LOUISIANA
ENERGY

Subject: Docket No.: 70-3070
Louisiana Energy Services
Claiborne Enrichment Center
Additional Information
File: 6046-00-2001.01

Attachment A
Additional Information Requested by NRC Staff

Comments Related to Facility and Site Decommissioning

Figure 1
Estimated Decommissioning Schedule

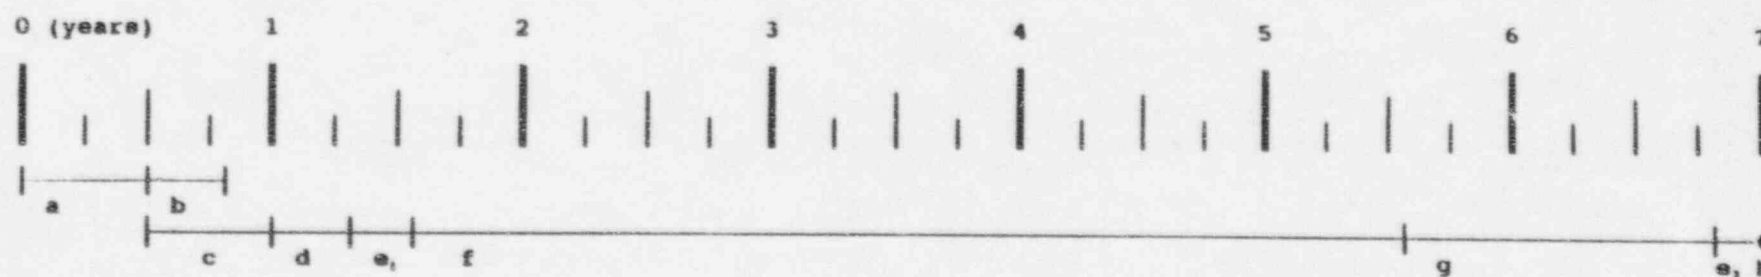
2. Revise your estimate of 2 months required to characterize the facility and site to six months. Assuming that the characterization plan is finalized before cessation of enrichment activities at the CEC, the staff anticipates that an additional six-month period will be required to complete facility and site characterization.

3. The staff anticipates that twelve months will be required to complete the final radiation survey, and an additional three months will be required to complete NRC's confirmatory survey. Revise the overall project decommissioning schedule accordingly.

The estimated time to characterize the CEC has been revised from two months to six months. The estimated overall schedule for decommissioning is shown in Figure 1 "Estimated Decommissioning Schedule."

The decommissioning schedule has been revised in accordance with the comment.
